DAVE BAXTER
Vice President
Oconee Nuclear Station

Subject: Duke Energy Carolinas, LLC
Oconee Nuclear Station, Units 1, 2, and 3
Renewed Facility Operating Licenses Numbers DPR-38, DPR-47, and DPR-55;
Docket Numbers 50-269, 50-270, and 50-287
License Amendment Request to Revise Portions of the Updated Final Safety
Analysis Report Related to the Tornado Licensing Basis;
License Amendment Request No. 2006-009

Subject: Proposed License Amendment Request to Revise the Updated Final Safety Analysis Report Related to the Oconee Tornado LB

Figure 1 Major SSF & PSW Electrical Power Upgrades

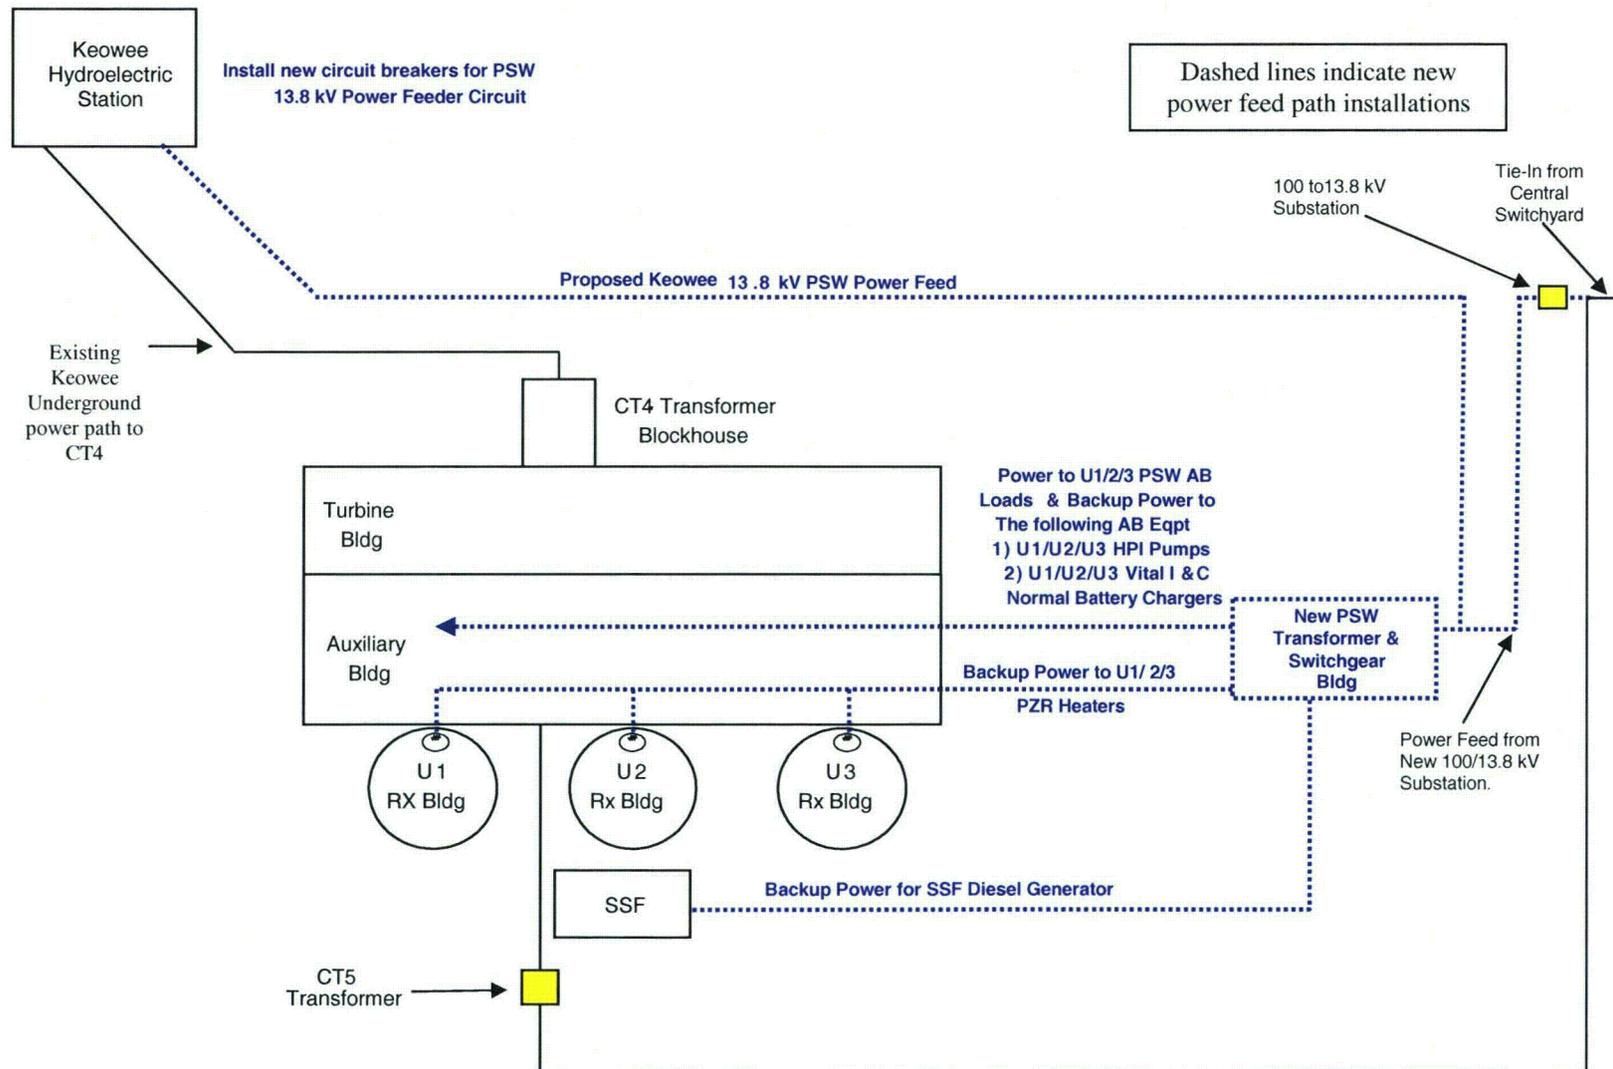
The Station ASW switchgear will be replaced with the PSW System switchgear located in a new tornado-protected PSW building. New power cables will be routed from the KHUs to the PSW building through an underground path. Alternate power to the PSW System switchgear will be provided by a new transformer connected to the existing 100 kV transmission line that receives power from the Central Tie Switchyard located approximately 8 miles from the plant. This new power path is strategically located on the opposite side of the station from the KHUs which reduces the chance of concurrent tornado damage to both power sources.

The new tap-off portion from the 100 kV line will not adversely affect the operation of the station's CT5 emergency transformer. Any fault that occurs on this new portion of line will be isolated from the 100 kV line with either the high side circuit switcher or the low side breaker installed at the PSW substation. The PSW switchgear will also provide a backup power supply to the SSF via an underground path as additional defense-in-depth. An electrical diagram displaying the revised power arrangement for the SSF and PSW Systems and the location of the CT5 transformer is shown on Figure 1.
